P/N 091-3007 has been superseded in the 3D, 3DS, & LW application by 088-1073

INSTALLATION INSTRUCTIONS: TO BE PERFORMED BY A QUALIFIED SERVICE TECHNICIAN

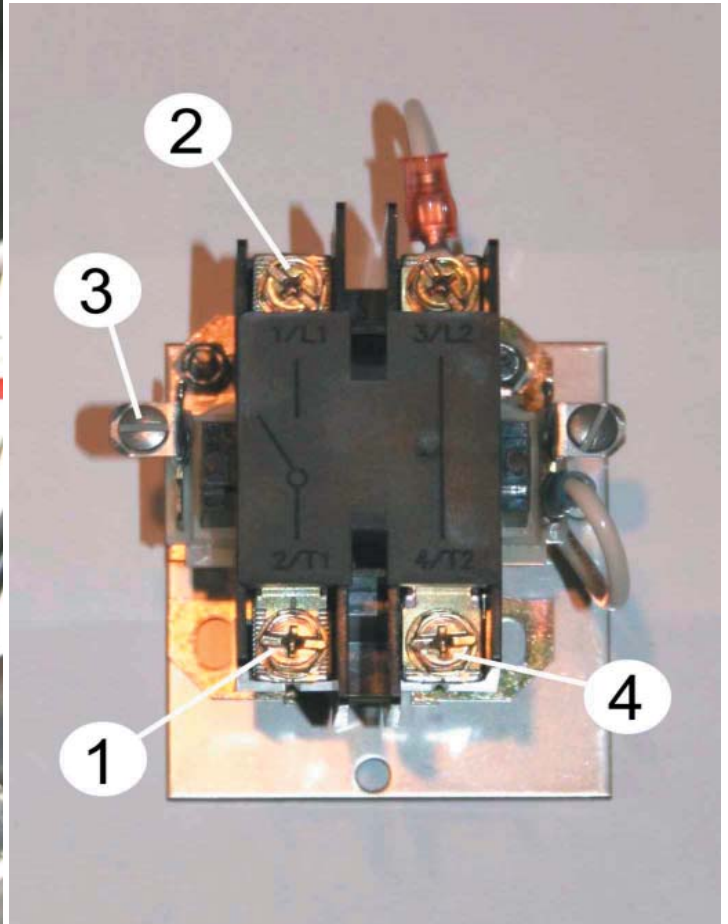
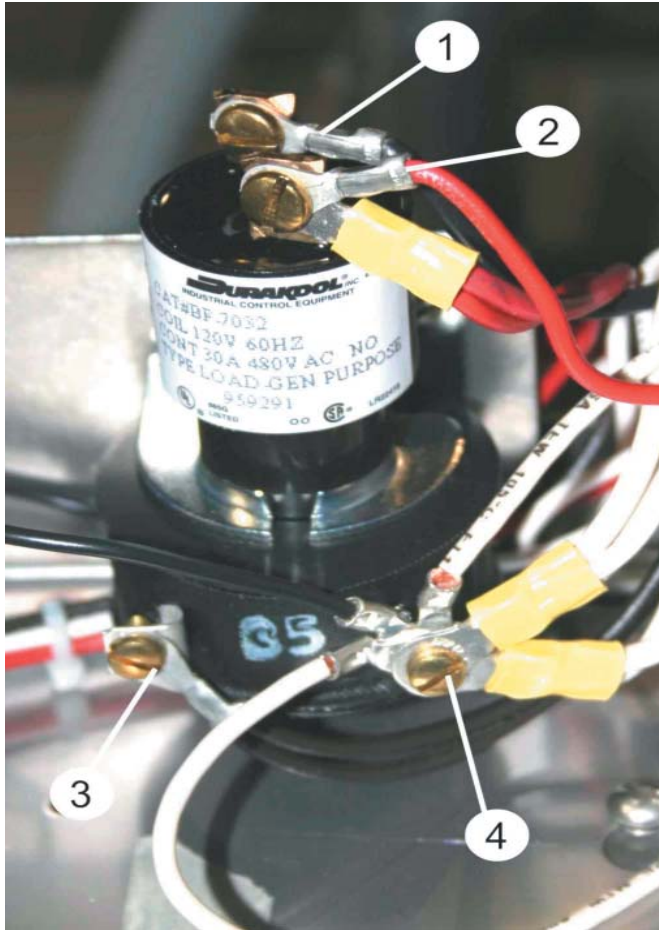
#2 Remove wires from existing mercury relay, and remove relay from the control box.

#3 Install new contactor and plate using existing bolts and nuts.

#4 Connect the black wire #1 on the mercury relay to position #1(T1) on the new contactor.

#5 Connect the red wires #2 on the mercury relay to position #2(L1) on the new contactor.

#6 Connect the brown wire #3 on the mercury relay to position #3 on the new contactor.

#7 Connect the white wires and the one black wire coming from the electric counter on #4 on the mercury relay to position #4 on the new contactor.
